**Sidewalk Replacement**

**Project:** 23050. / Northern Lebanon MSHS Additions & Renov  
345 School Drive  
Fredericksburg, PA 17026

**Scope of Work:** Provide removal and replacement of 3,424 SQFT of 4" sidewalk per owner request.

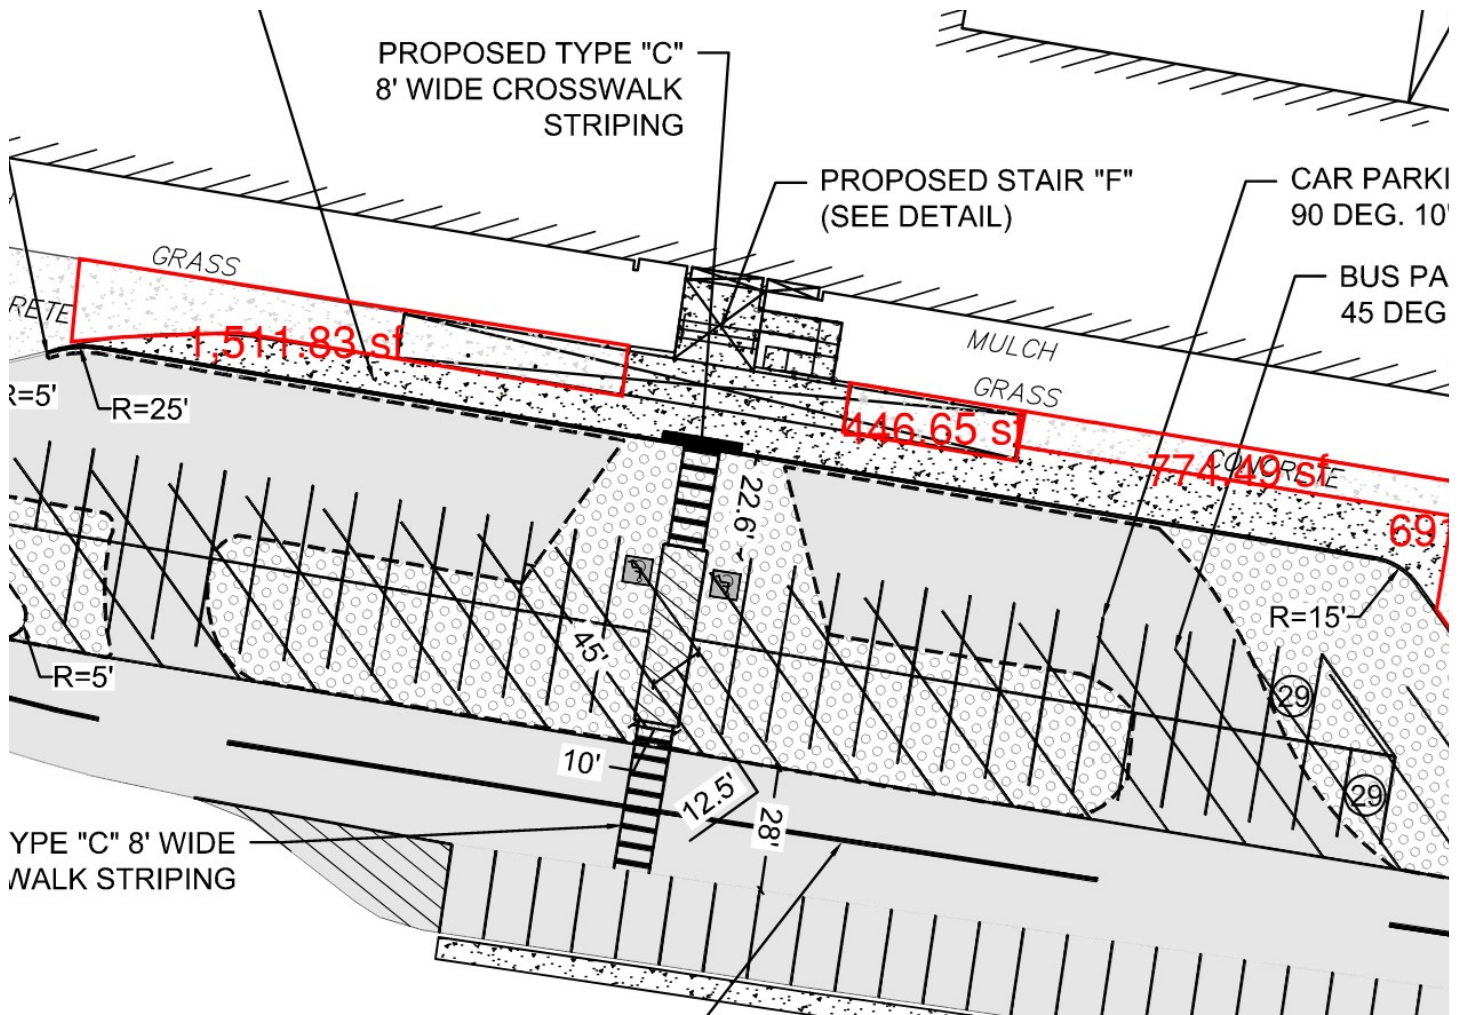
We do have an allowance of 1000 sqft of NEW sidewalk in the contract which is amount of \$8,200. The areas Brad mentioned are noted below and I broke them down for evaluation, overall this comes out to +/- 3,424 SQ FT which would be a cost of \$38,006.

One other thing to mention would be the existing canopy and placing the sidewalk, if we are limited in overhead clearance around the canopy and need to pump this, the pump cost would be an additional item to note, I would budget \$1,200 for this cost.
